ADDENDUM NO. 1

PROJECT: City of Hot Springs
Ouachita WTP Backwash Tank Repainting and Repairs
Hot Springs, AR 71901

ROOF DETAIL

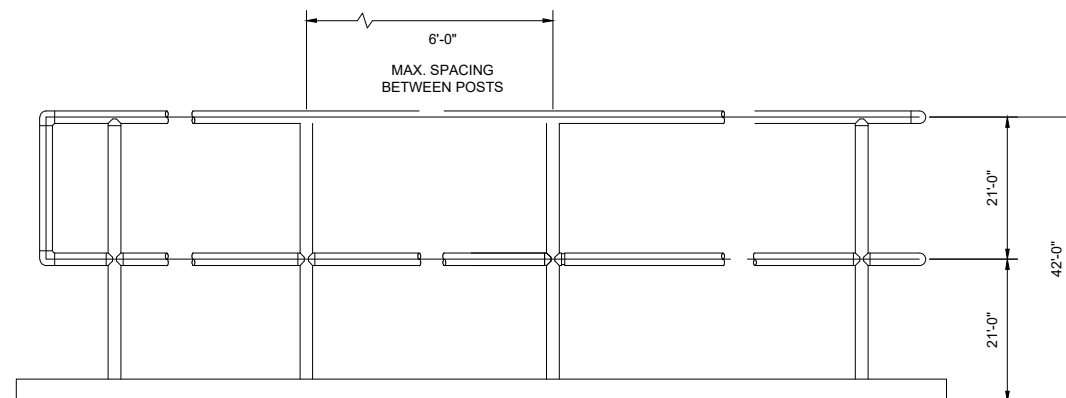
Revise Roof Detail

Remove General Note "Sterilize tank in accordance with AWWA C652-92 and project specifications" and replace with "Sterilize tank in accordance with AWWA C652-19 and project specifications"

Sheet One: "Existing Roof Detail"

Remove "Existing Roof Detail" replace with "Roof Detail"

Please see added dimension to "Roof Detail"
